7916 WHITE CLIFFS DR

Groundwater and Wastewater Services File Imaging Project

Permit Number: 3731B

MECKLENBURG COUNTY HEALTH DEPARTMENT
SITE EVALUATION REPORT
SERIAL NUMBER 028750

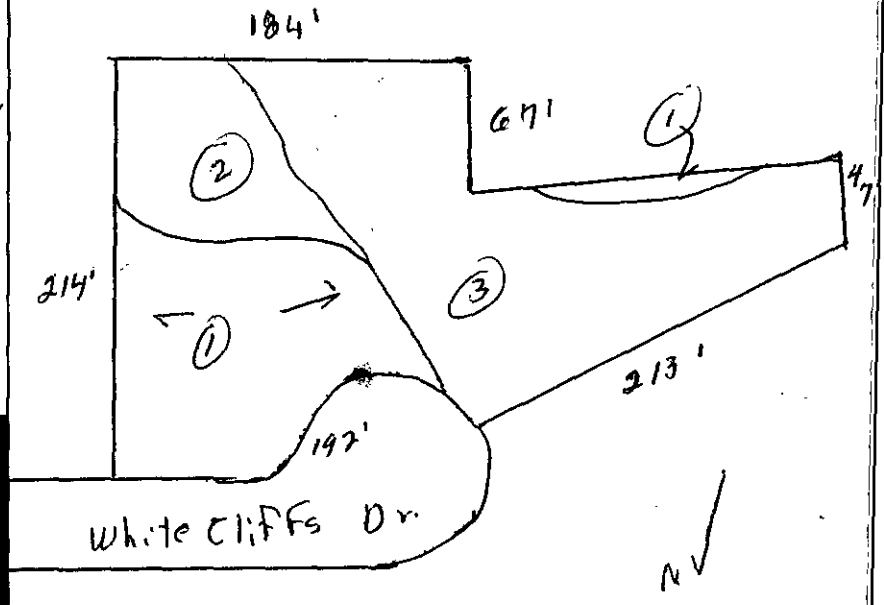
Comments: 100% Repair, .3 gal/ft/day by LTAR

MECKLENBURG COUNTY HEALTH DEPARTMENT
SITE EVALUATION REPORT
SERIAL NUMBER 028750

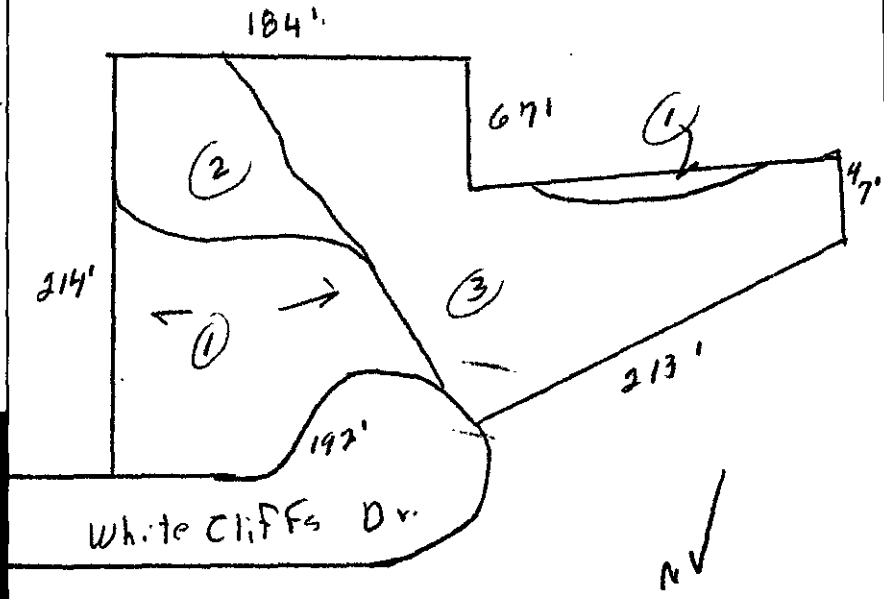
Comments: 100% Repair, .3 gal/ft/day LTAR

* Trench Profile if Shallow Placement Required

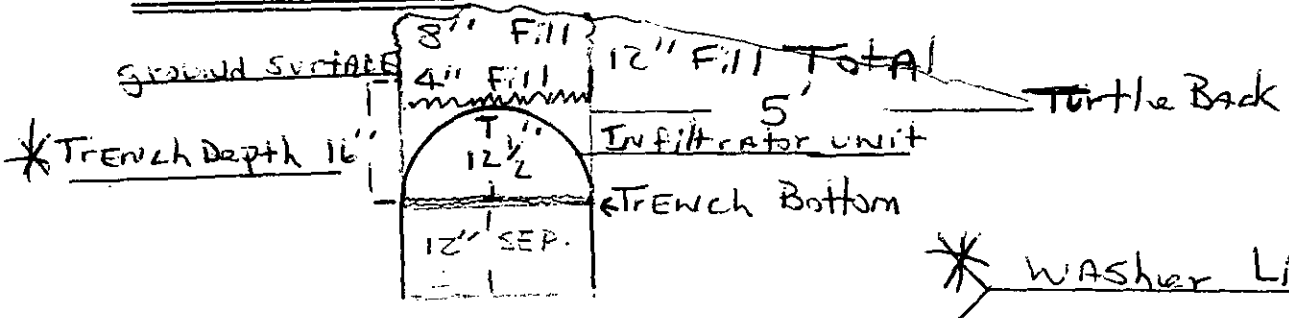
16" Trench Depth
12" Total Cover Approved
by M.C.H.D.
